BUILDING ENVELOPE REPORT

SUNNINGDALE PRIMARY SCHOOL

22nd May 2019

EIW ARCHITECTS

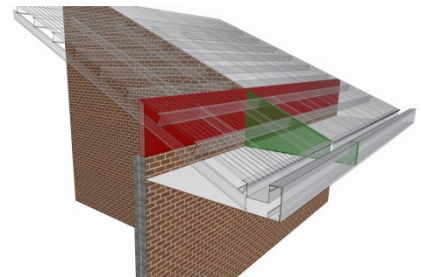
It is also critical that all perimeter open eaves are closed off with a full height wall detail. This can either be achieved via the perimeter wall continuing up to the underside of the roof sheeting above (red area in the adjacent image), or by continuing the separating partition walls out to the edge of the eave lining (green area in adjacent image).

DRAWN: TG	DESIGNED: EIW	
CHECKED: AD	PRINCIPAL:	
APPROVED:		
SCALE: 1:100	DATE: JANUARY 2019	DRAWING No:
BMW PROJECT No:	EIW PROJECT No: 1820	SK2.01
BMW FILE No:	EIW FILE No: SDP SK2.01 PS

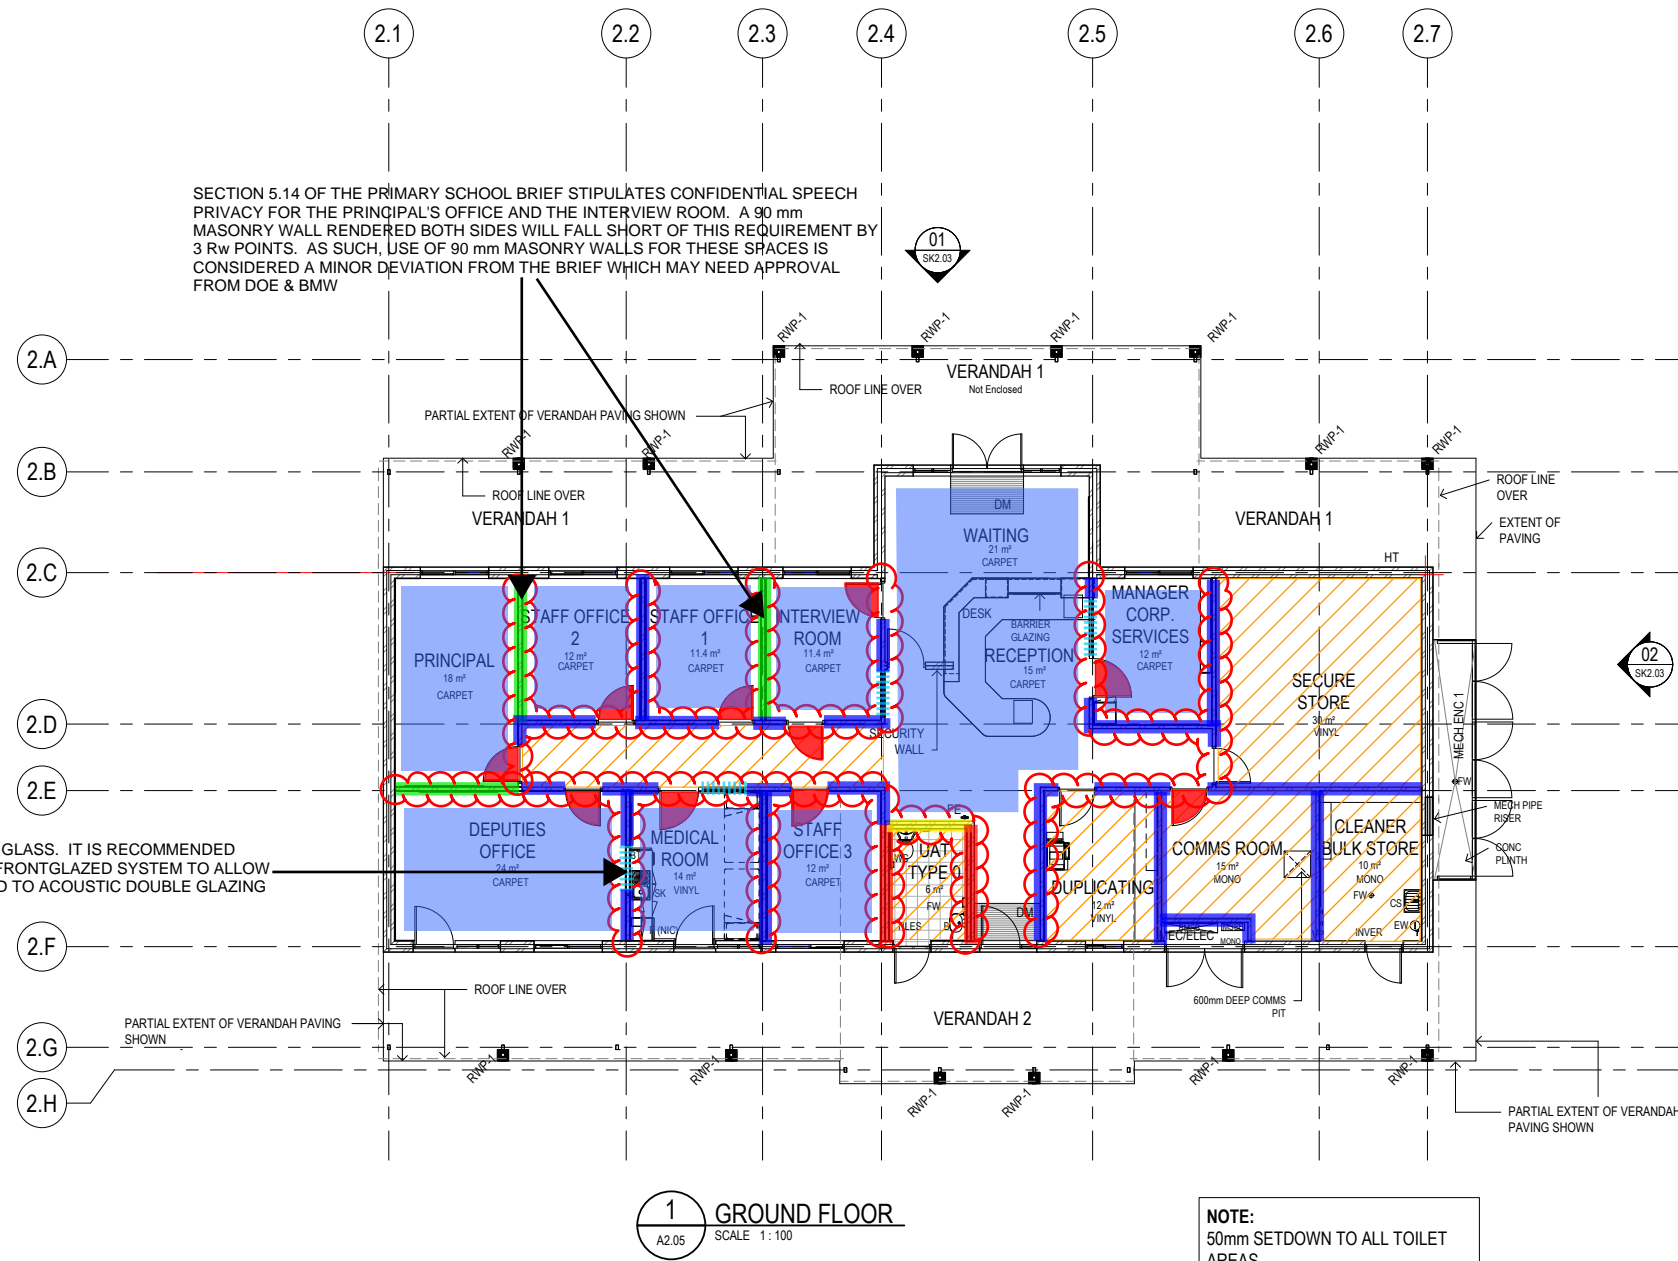
AAT to Reception. Discontinuous Type W4 wall construction is recommended here to reduce structure-borne cistern flush and fill noise, even considering the expected low occurrence of simultaneous occupancy.

DRAWN: TG	DESIGNED: EIW	
CHECKED: AD	PRINCIPAL:	
APPROVED:		
SCALE: 1:100	DATE: JANUARY 2019	DRAWING No:
BMV PROJECT No:	EIW PROJECT No: 1820	SK4.01
BMV FILE No:	EIW FILE No: SDP SK4.01 PS

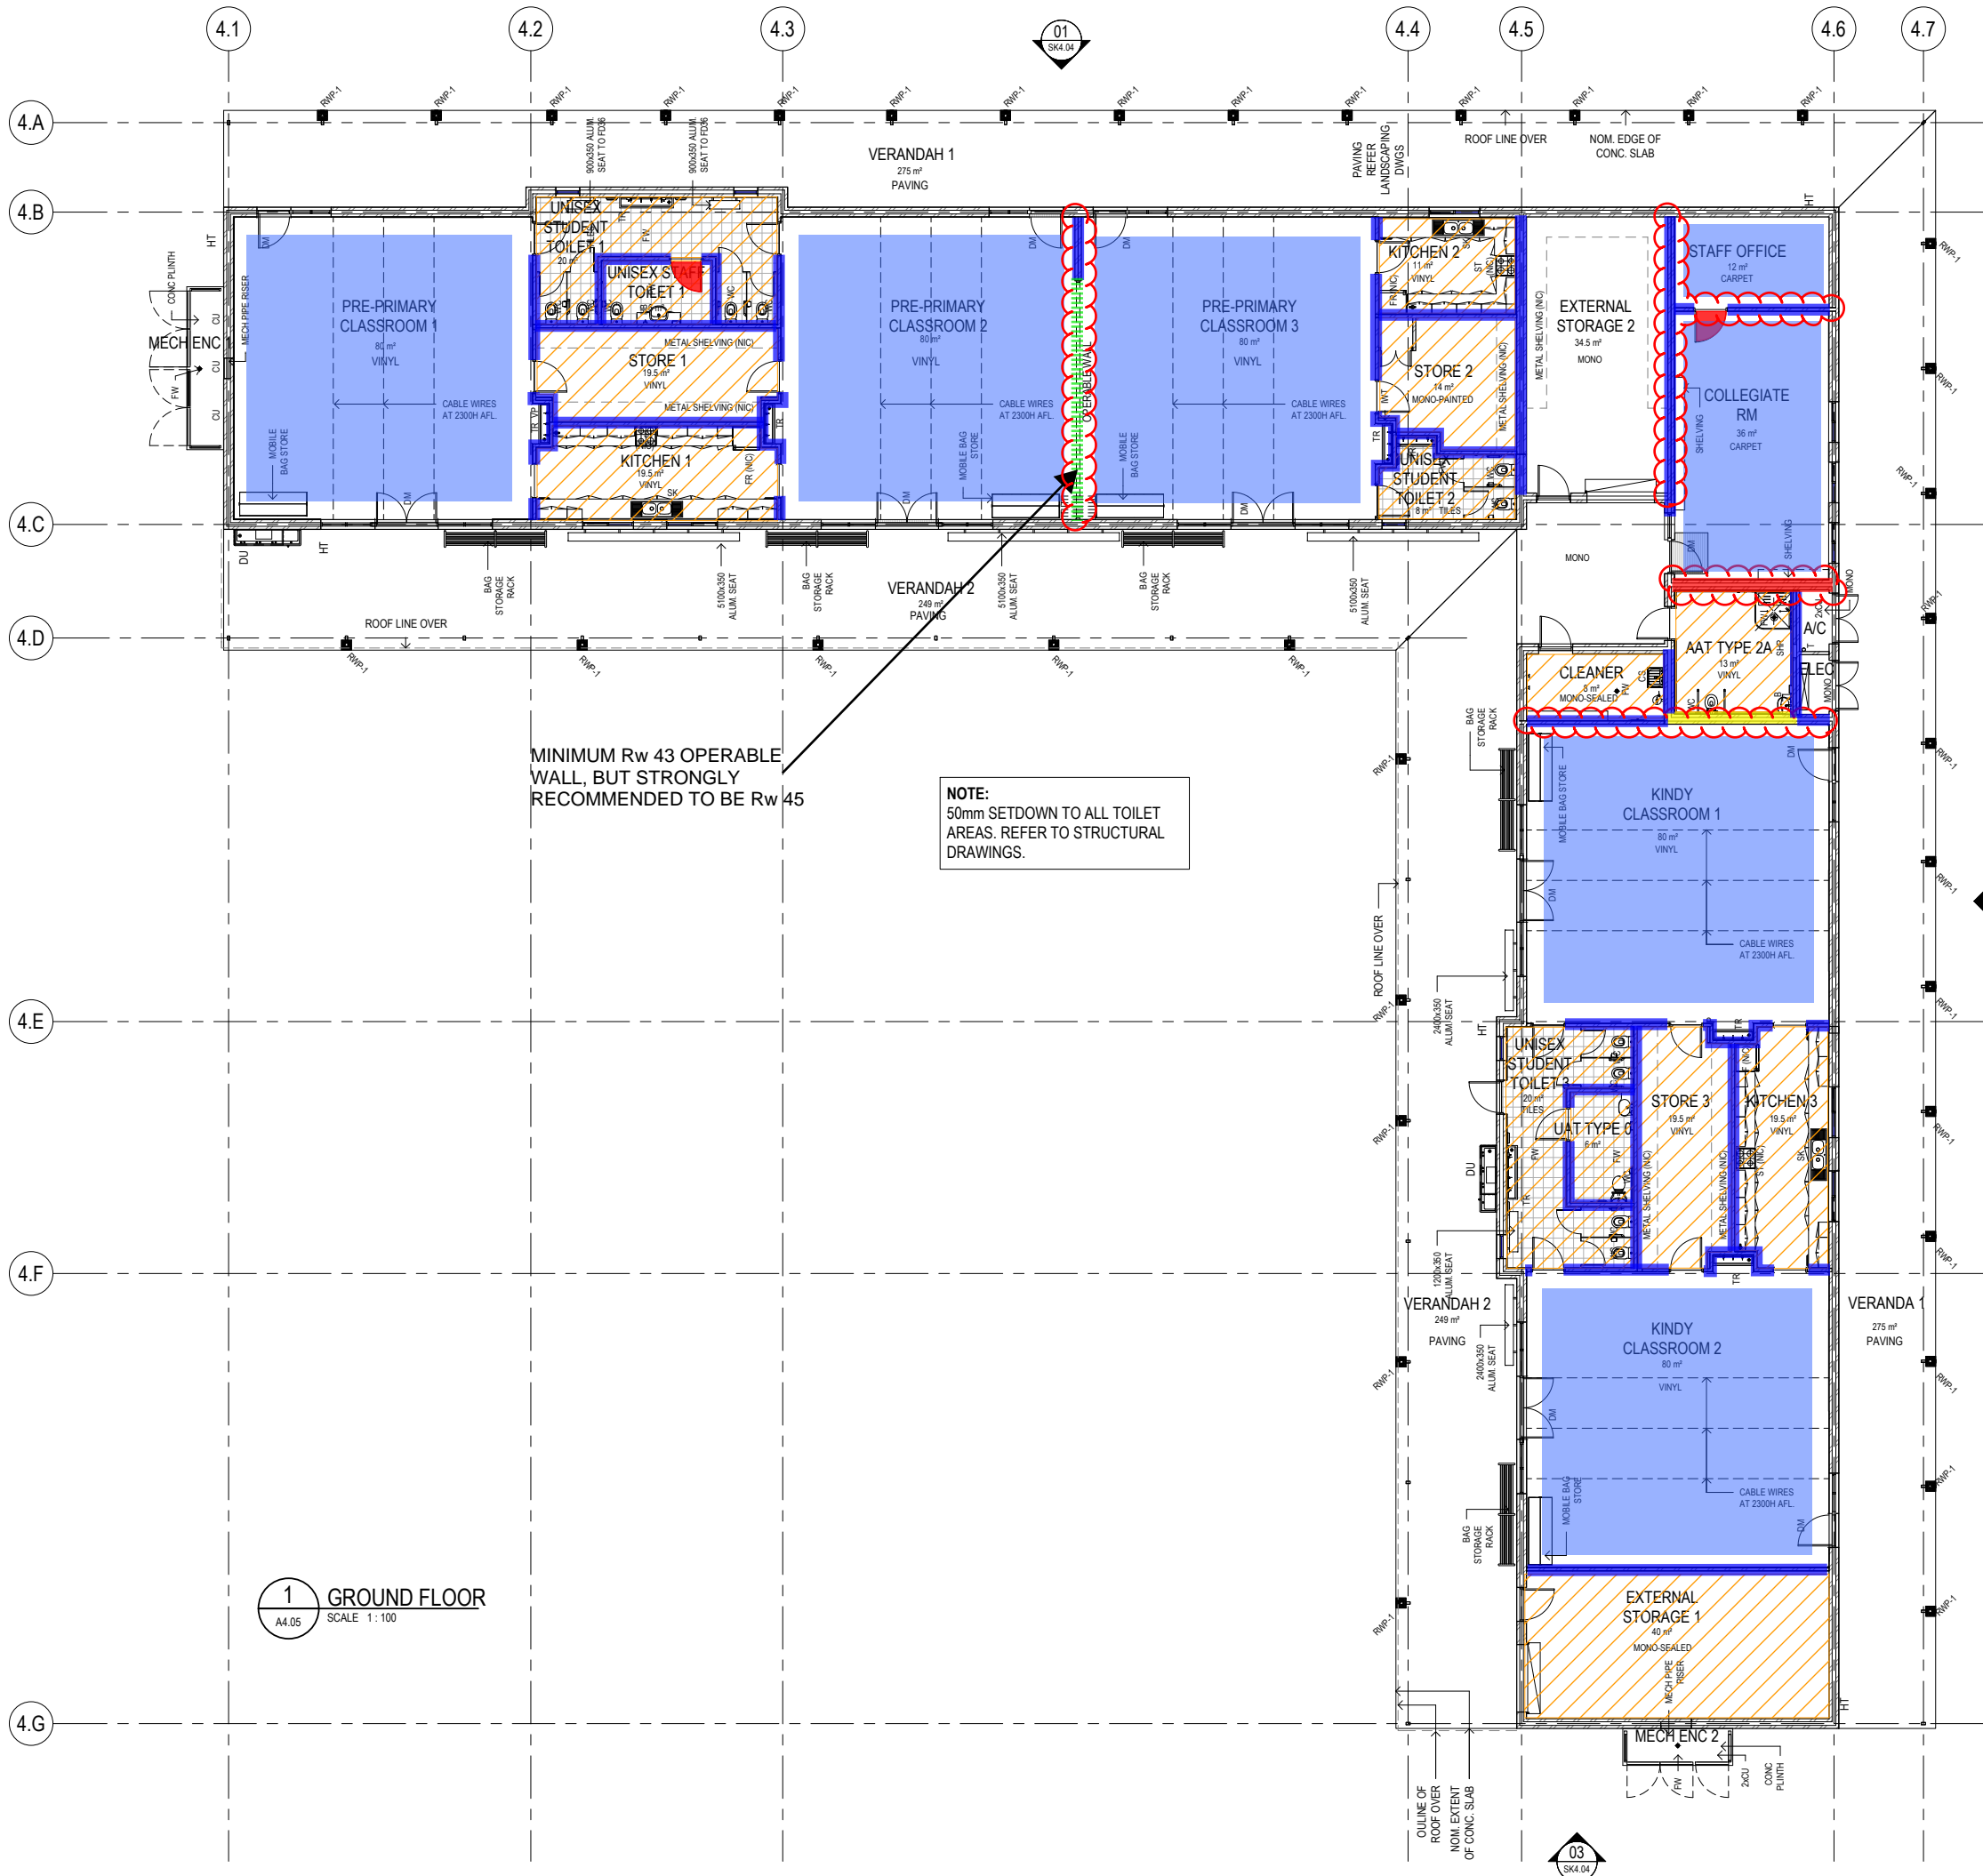
MINIMUM R_w 43 OPERABLE WALL, BUT STRONGLY RECOMMENDED TO BE R_w 45

DRAWN: TG	DESIGNED: EIW	DRAWING No: SK7.01
CHECKED: AD	PRINCIPAL:	
APPROVED:	DATE: JANUARY 2019	
SCALE: 1:100	BMW PROJECT No: 1820	
BMW FILE No:	EIW FILE No: SDP SK7.01 P5

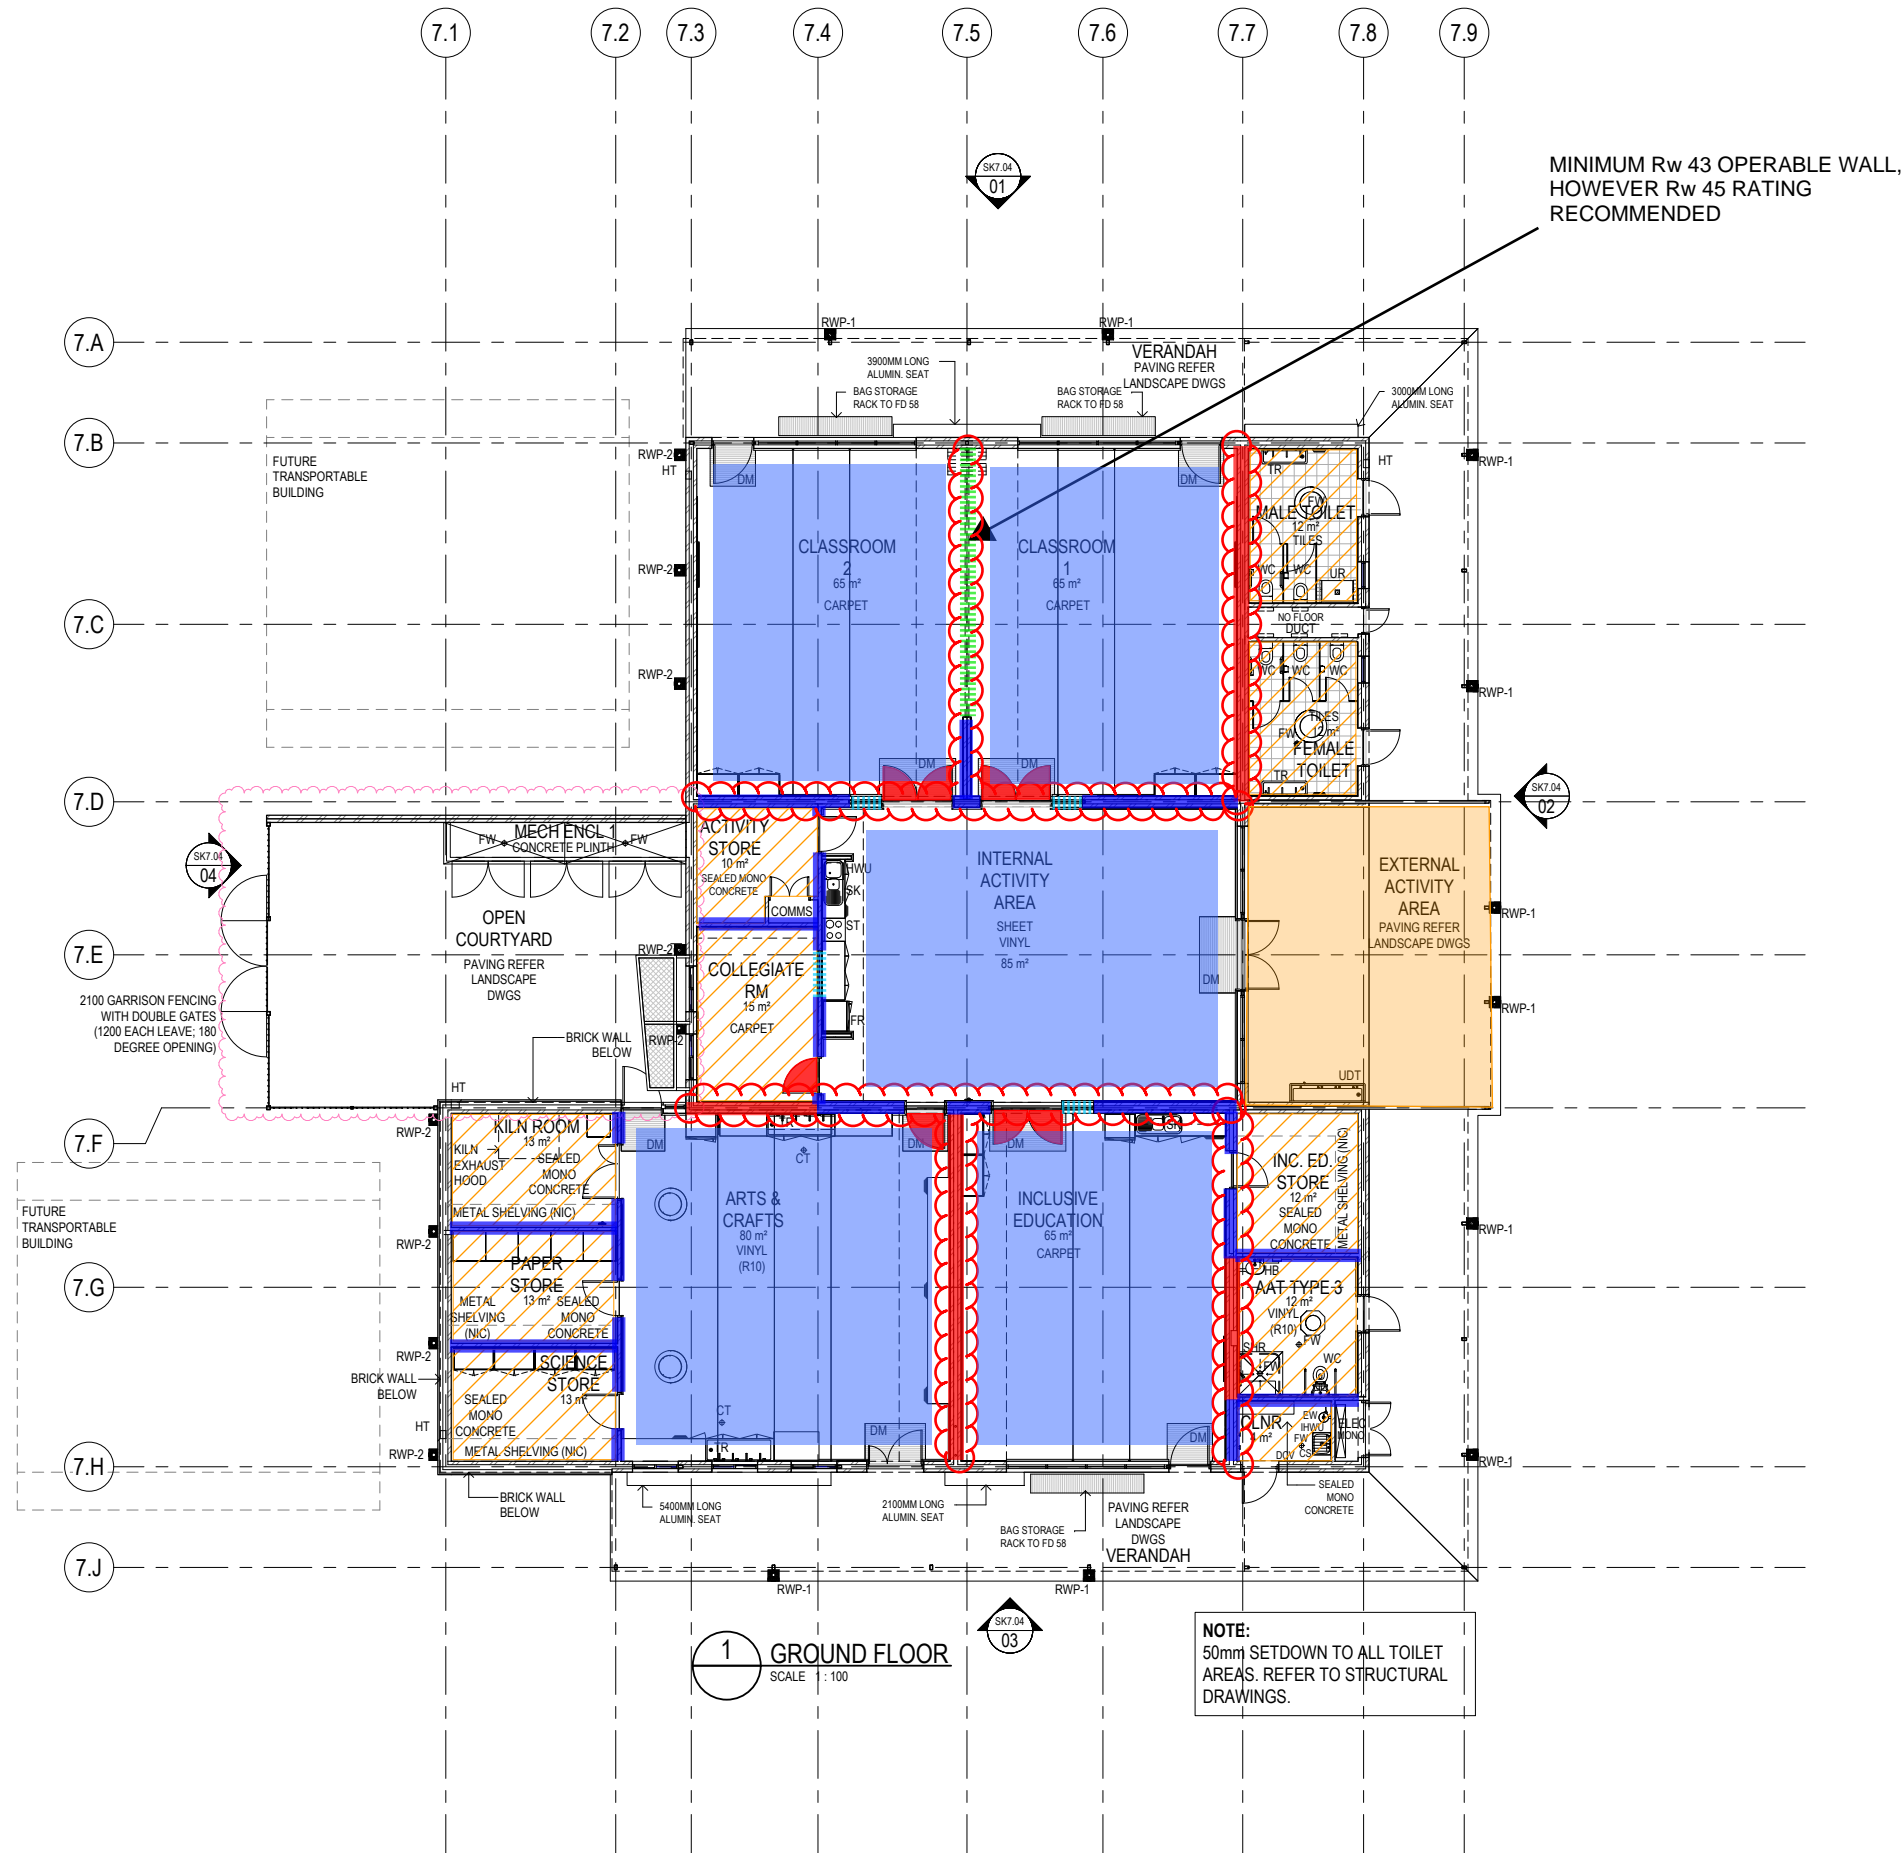
MINIMUM Rw 43 OPERABLE WALL,
 HOWEVER Rw 45 RATING
 RECOMMENDED
